ADDENDUM No. 3
REQUEST FOR TENDER No. Doc4704136526
SUBMISSION DEADLINE: 12:00 NOON (LOCAL TIME), SEPTEMBER 19, 2024
FOR: Generator Replacement (51 Division) Located at 51
Parliament Street, Toronto

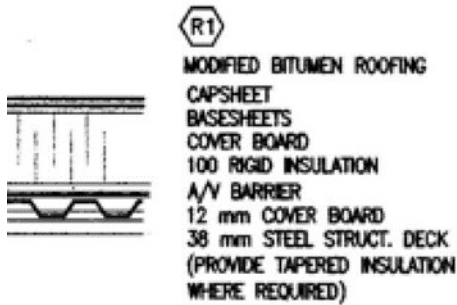
Q7 – The drawing mention coordinating the costs to relocate the existing satellite dishes with the base building contractor. Please advise who the contractor is so we can reach out to them for pricing.

A7 – The Client has advised that the satellite dish is no longer in use as they have switched over to Bell. It is now required to be removed.
